**IFB NO. 500620-FY19-49
WIRT STREET WATER LINE IMPROVEMENTS**

ADDENDUM NO. 1

MAY 24, 2019

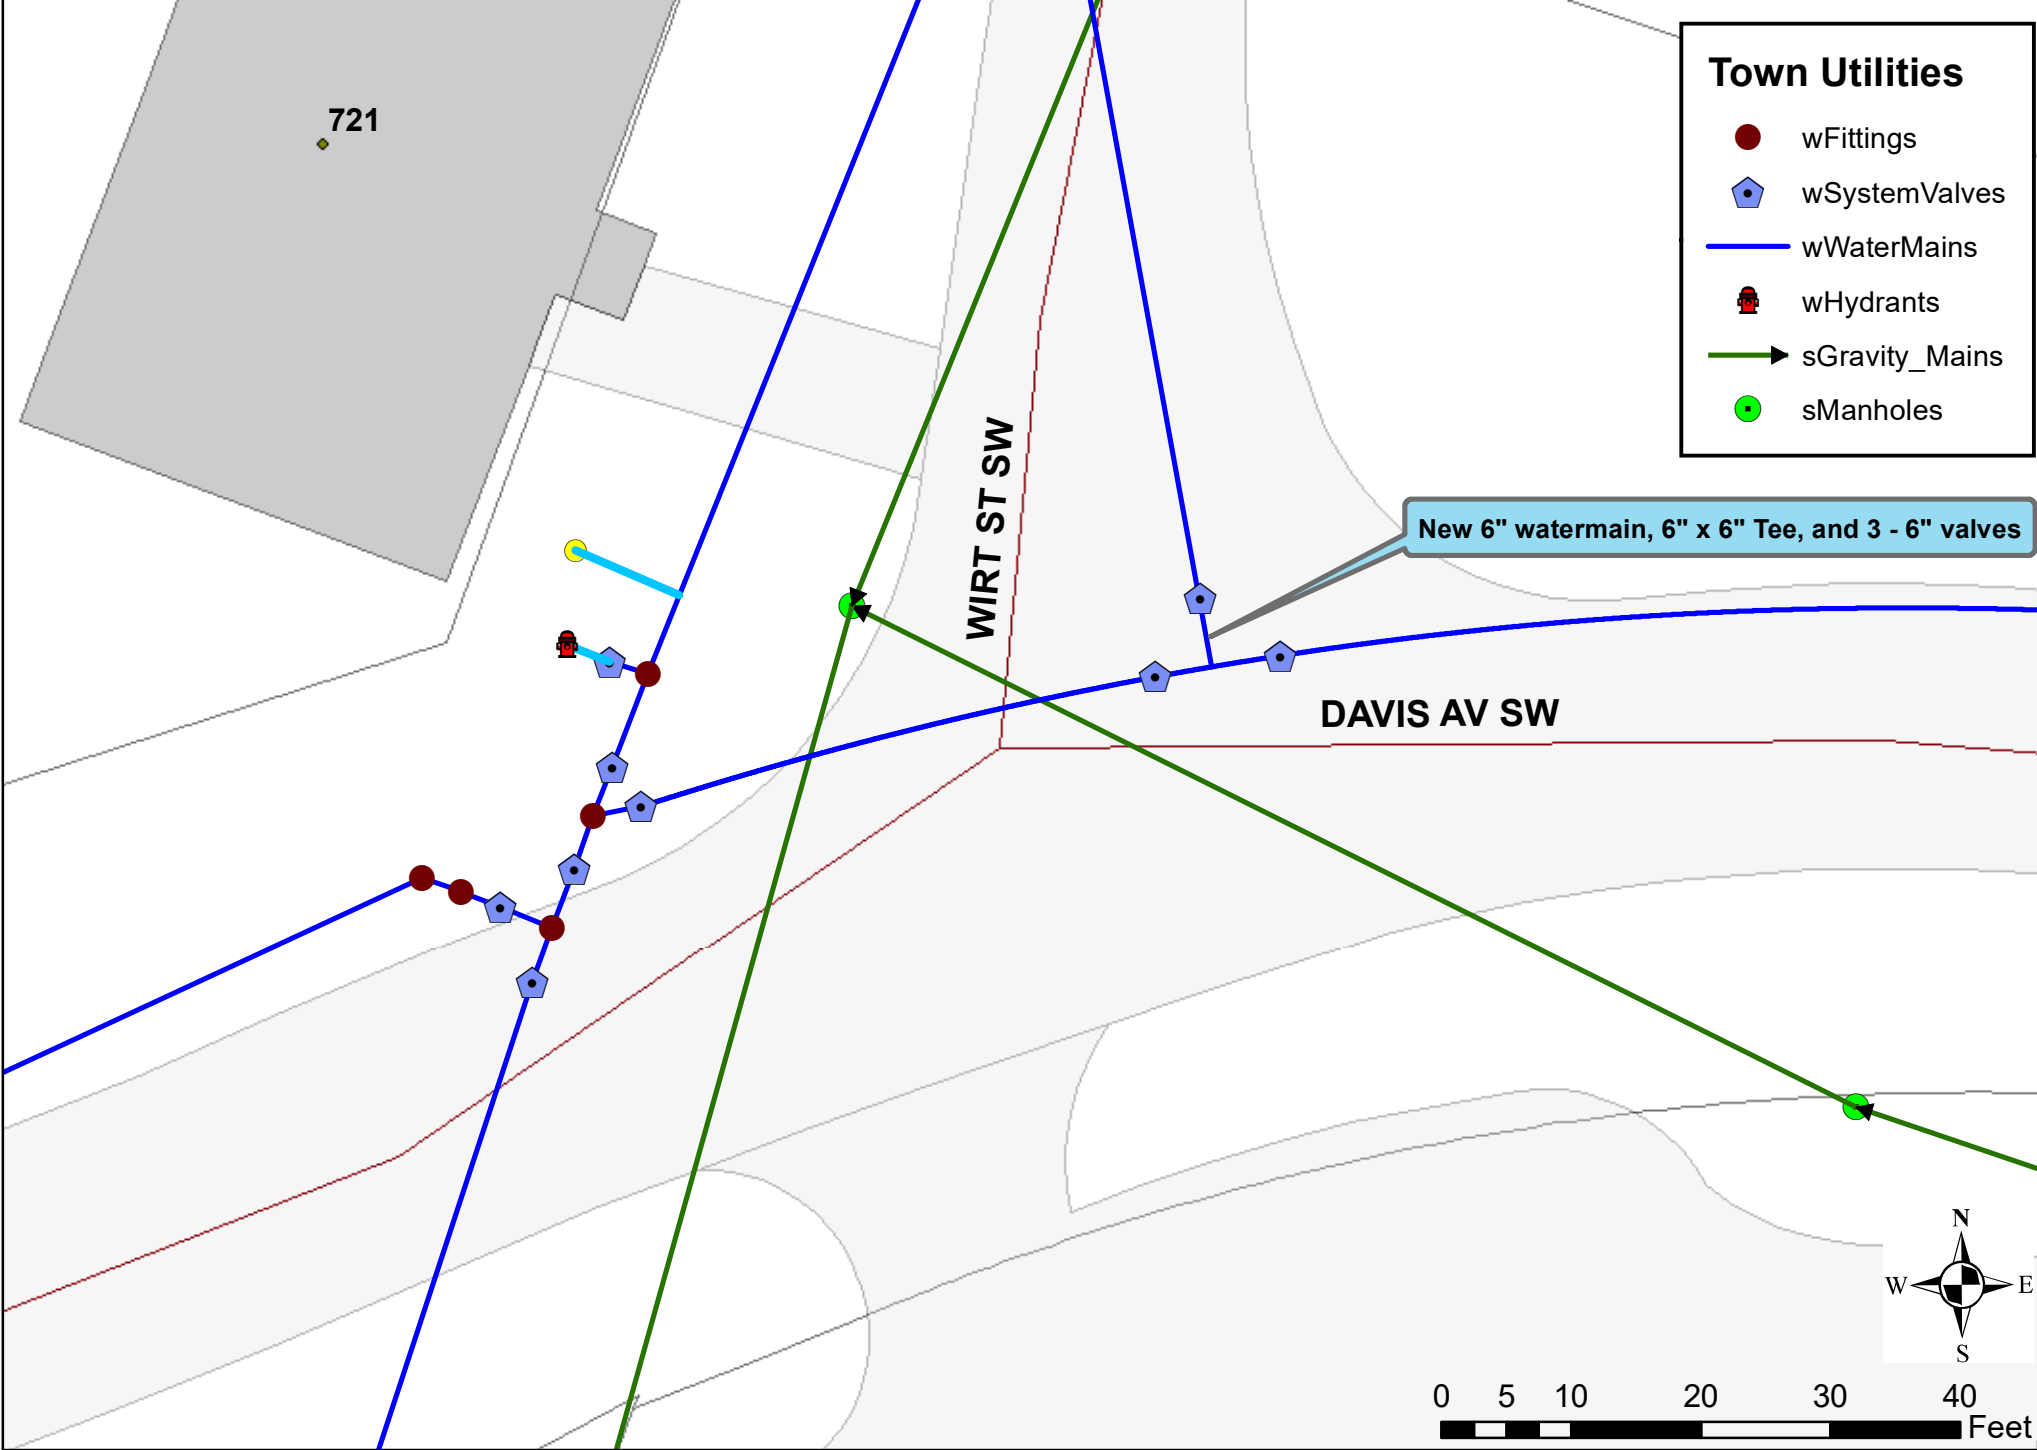
Install 6" x 6" tee, 6" valve, and new fire hydrant in location designated by Town Project Manager.
Fire Hydrant leads are C900.

Replace 50' of old 6" sewer main with 8" C900

Add anchor collar on east side of existing 4" valve.

Replace fire hydrant and appurtenances.
Fire Hydrant leads are C900.

Install 6" x 6" tee and 3 - 6" valves.
Plug the south valve.
Extend new 6" C900 watermain north and east to Tie-In Location "C".

Tie-In Location "D"
Close 4" valve and tie new 6" waterline using bends and 6" MJ Sleeve. Connect to and extend existing Tracer Wire.

Tie-In Location "C"
Set BOV and Test new waterline.

Remove Plug and Blow Off Valve at Location "A".
Extend 6" C900 waterline. Connect to and extend existing Tracer Wire.
Install 6" x 6" tee, 6" FH valve, new fire hydrant and a 6" valve west of tee at location designated by Town Project Manager.
Fire Hydrant lead to be C900.
Test new waterline and fire hydrant.

Tie-In Location "E"
Remove 6" plug from south valve and extend new 6" C900 waterline south to Tie-In Location "F"

After new waterline and FH accepted by Town, extend new 6" C900 Waterline from new 6" valve westward to Tie-In Location "B".

Tie-In Location "F"
(1) 6" x 6" tee
(3) 6" valves
SEE LOCATION 'F' EXPLODED VIEW

Tie-In Location "F"
(1) 8" x 8" tee
(2) 8" valves
(1) 8" x 6" reducer
(1) 8" x 4" reducer
(1) 6" 90° HB
SEE LOCATION 'F' EXPLODED VIEW

Remove fire hydrant and appurtenances.

LOCATION F - STEP 1

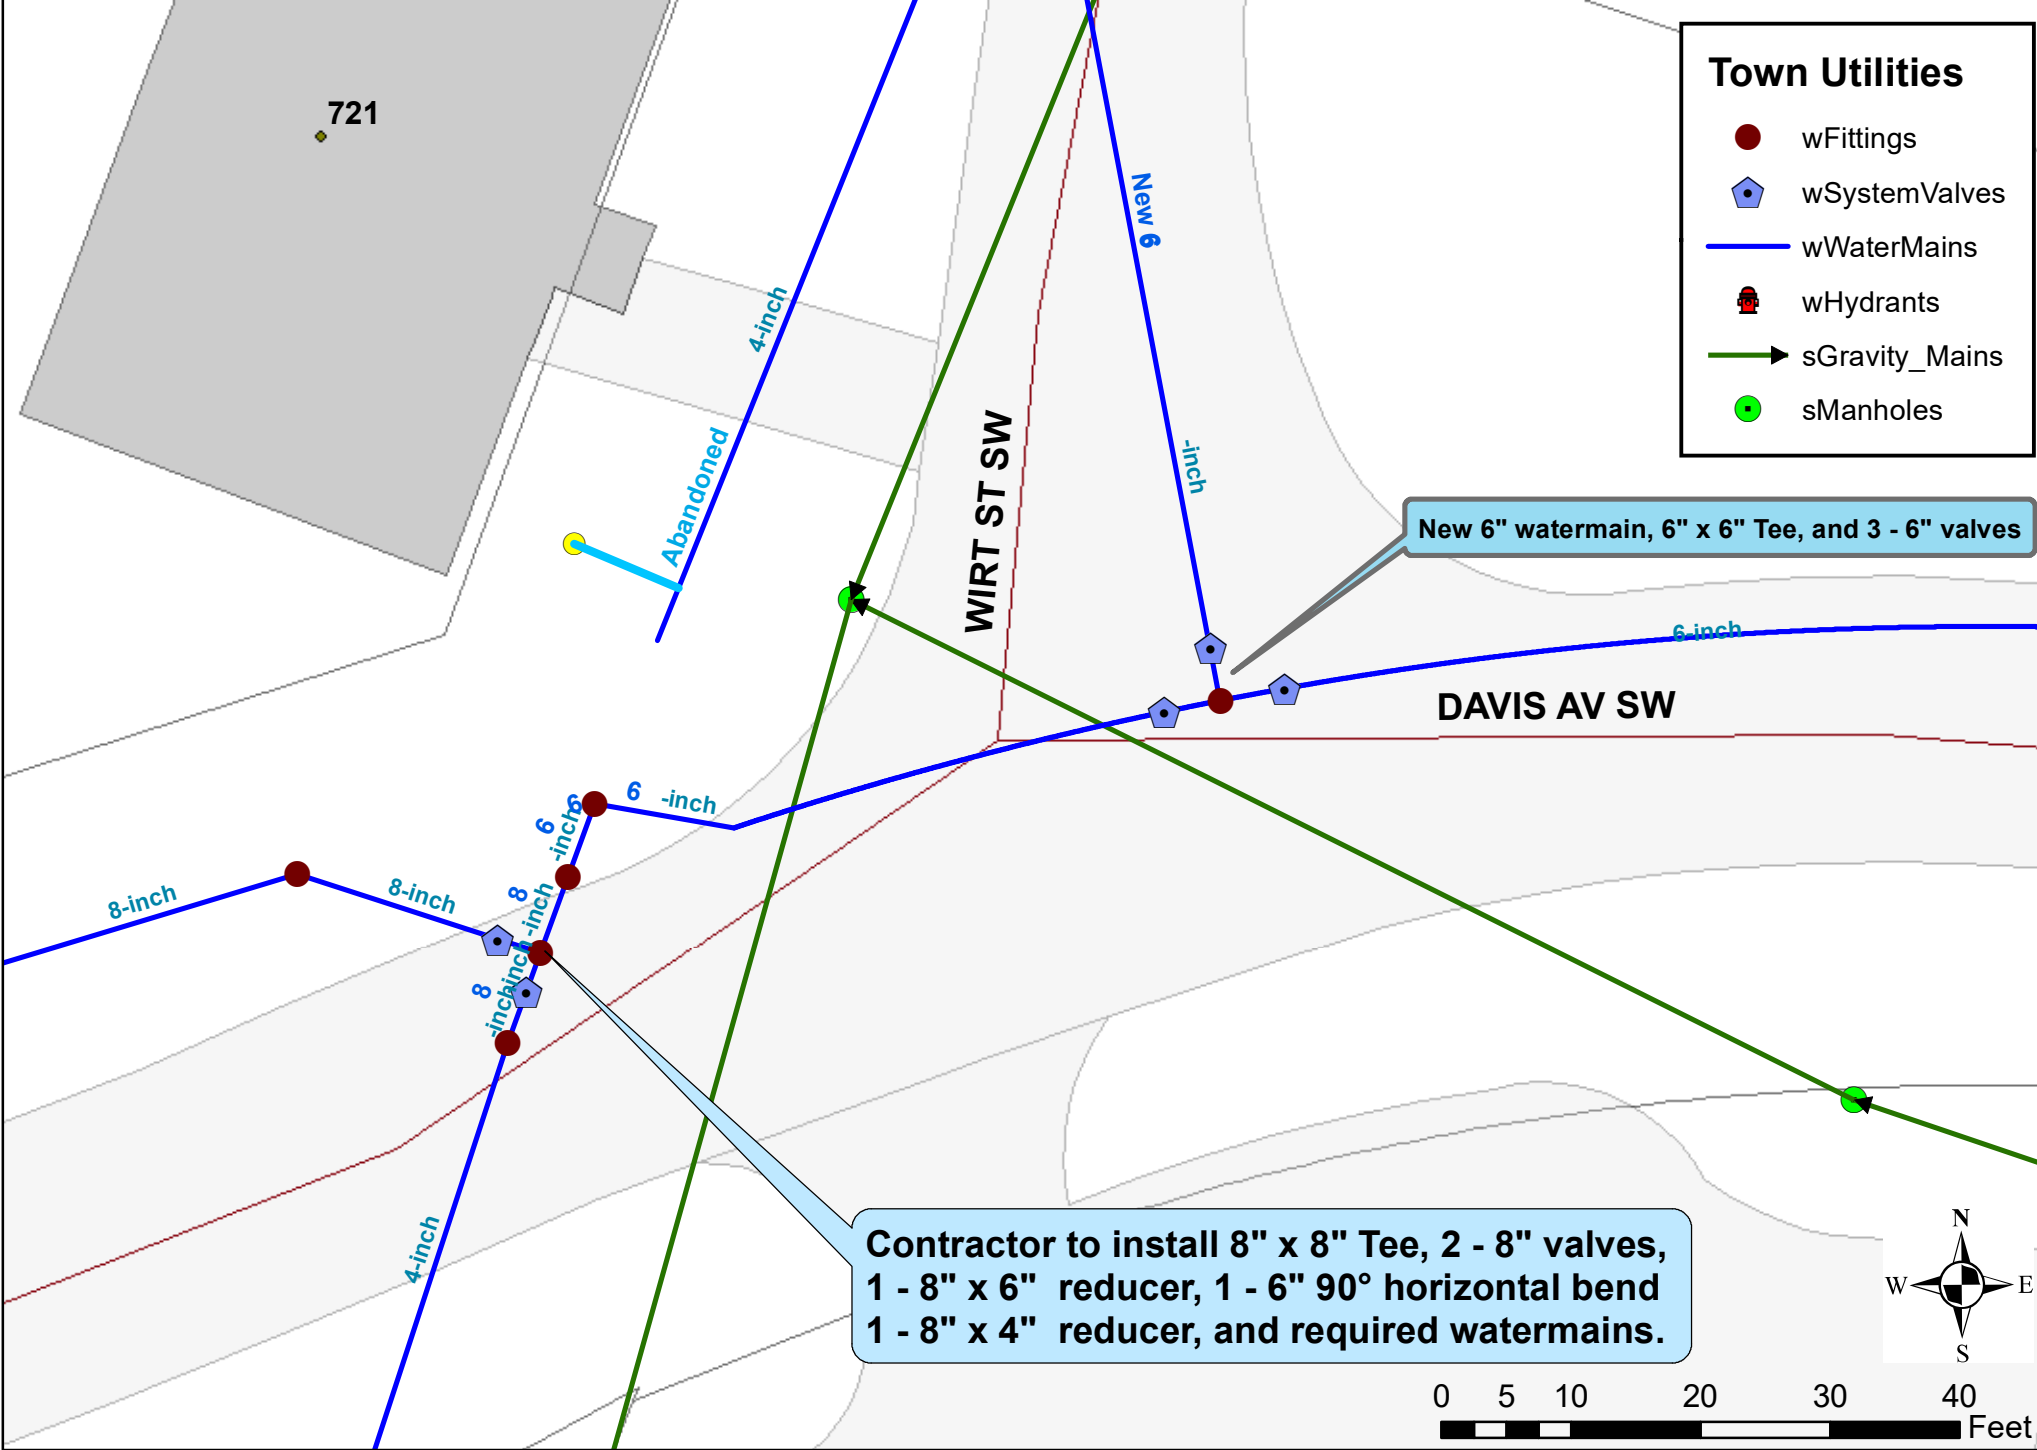
Response 2: This project will upgrade the 4” water lines that run perpendicular to Wirt St SW on Davis Ave near the intersection of Wirt St SW and Davis Ave SW to 6” and 8” lines. See the attached sketches labeled Location F- Step 1, Location F - Step 2, and Location F- Step 3 for details of water line abandonment and new installation. There are valves available that may be used for shut offs.

ISOLATE DAVIS AVE EXISTING 6" WATERMAIN

CUT IN 6" x 6" TEE AND 3 - 6" VALVES - TIE NEW 6" WIRT ST WATERMAIN TO 6" VALVE
